# **84 LUMBER COMPANY SITE DEVELOPMENT**

SP# 09-22

## **STAFF REPORT**

Re: Town of Hudson Planning Board Review  
84 Lumber Site Plan, 3 Sullivan Road  
Tax Map 145 Lot 15; Acct. #1350-529  
Reference No. 20030249.2210

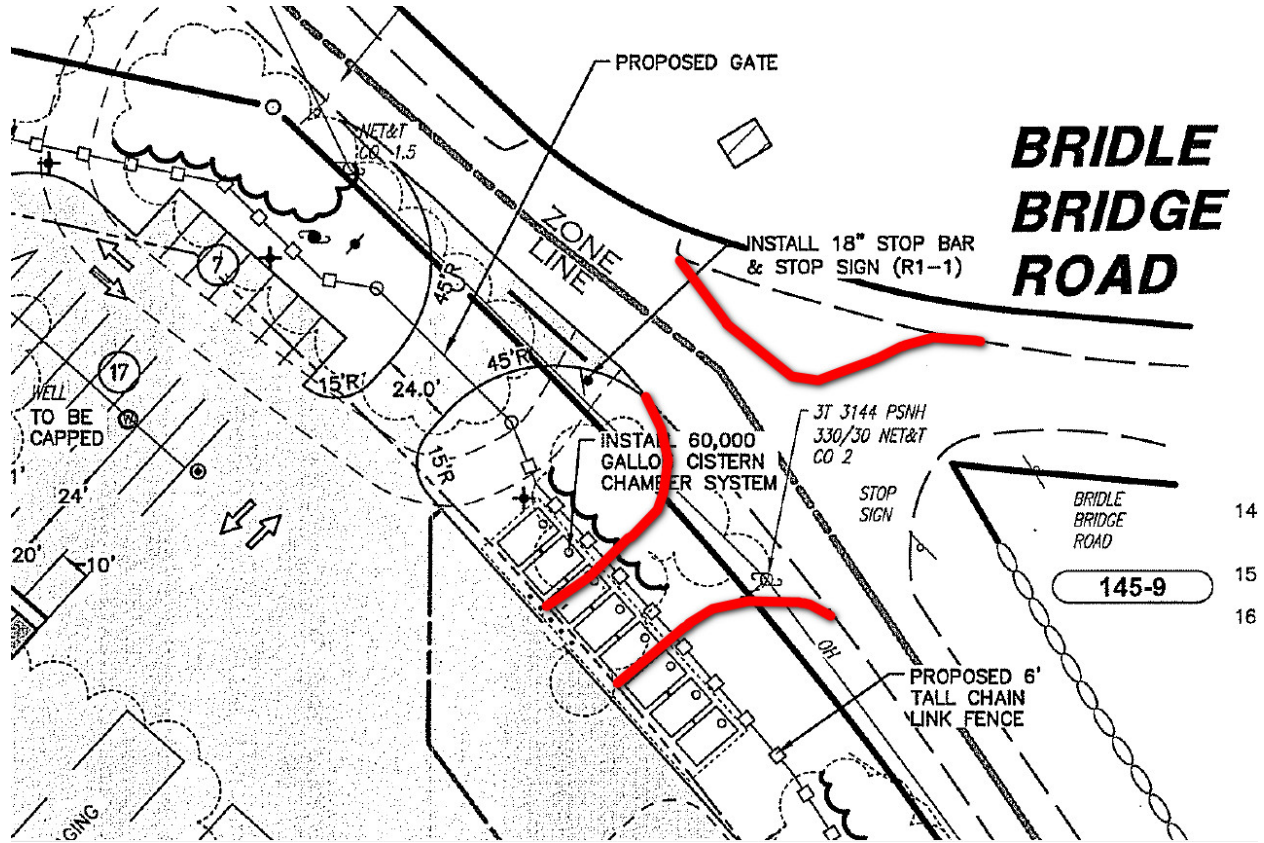
1. Applicant shall provide mechanical/oil separator for CB 6, 9 & 12
2. Applicant shall reevaluate the location of the entrance and try to line it up with Bridle Bridge Road (mimic a two way stop intersection)
3. Applicant shall consider offsite improvement, per attachment
4. Currently the applicant is proving 1 hour fire suppression at 1,000 gallons per minute (60,000 gallon cistern), minimum is 3 hours.
5. Applicant shall provide details regarding ownership and maintenance of the proposed cistern
6. Applicant shall provide sight distance plan and profile of the proposed entrance

*An oil separator is proposed on catch basins 6, 9, and 12 on sheet GR-1 and detailed on sheet DT-3.*

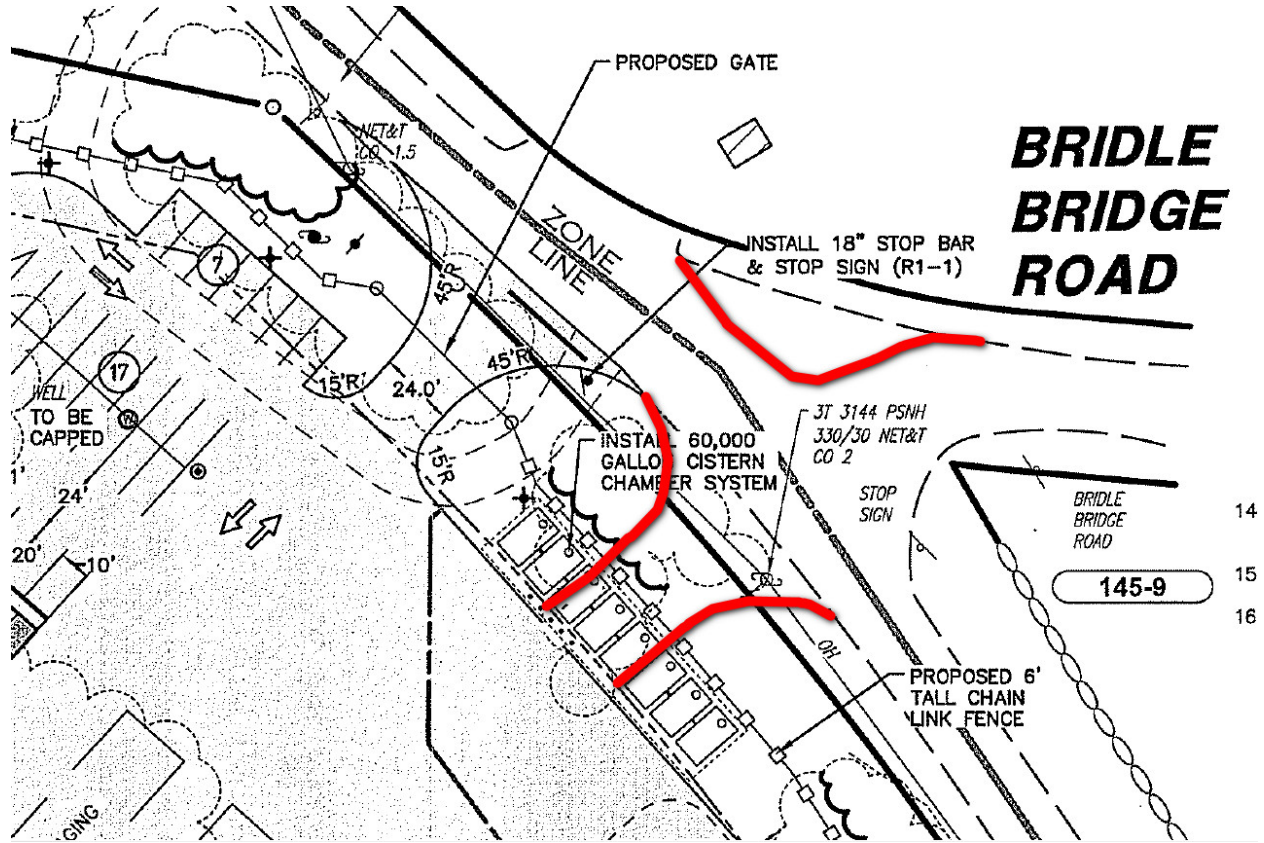
1. Applicant shall install conservation plates every 50 feet along the 50 foot wetland buffer
2. Applicant shall not store snow within the wetland or wetland buffer
3. Applicant shall consider installing guard rail along the detention basin ( 7 foot plus drop)
4. Applicant indicates drainage pipe slopes less than 2%. Applicant should consider reducing the cover over the pipe to increase the slope

3. Applicant shall consider offsite improvement , per attachment ( I'm looking for a yes or a no on this one )
4. Currently the applicant is proving 1 hour fire suppression at 1,000 gallons per minute (60,000 gallon cistern) , minimum is 3 hours.
